THREE KINGS RENEWAL, ADDENDUM TO STORMWATER MANAGEMENT PLAN, OPTION 15H1

This letter forms an addendum to the Three Kings Renewal Stormwater Management Plan produced by Pattle Delamore Partners in September 2014. The addendum addresses questions identified by Auckland Council in their correspondence to Fletcher Residential Ltd of 26th August 2014 and 24th September 2014. The points addressed by PDP are items 48, 51, 54 relating to correspondence on 26th August and items 5.4, 8.1, 8.2, 8.5, 8.6, 8.13 relating to correspondence on 24th September 2014.

Figure 1: Soakage Trench

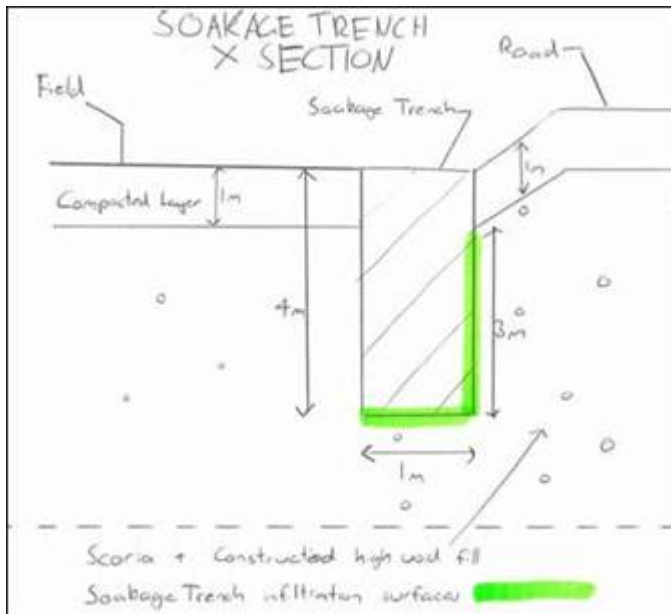
Please provide further information on the expected flooding frequency/duration of the proposed sportsfields and the likely impact on use of the fields (i.e. field closures, additional maintenance and field repair following storm events).

This is an assessment of the time taken to fully discharge stored stormwater from the fields to ground at the proposed Three Kings Renewal development for a range of rainfall events and soakage rates. This requires a conceptual design of the soakage method to the local and wider ground conditions.

Ultimate stormwater disposal from the sportsfields has been assumed to occur via soakage trenches excavated into the scoria at the south side of the field areas (as shown in Figure 1 below). For this conceptual design, five soakage trenches of length 50m each have been used (for a total of 250m of actual trench). Infiltration has been assumed to occur only through one wall towards the perimeter of the site and through the base of the soakage trenches (green on Figure 1).
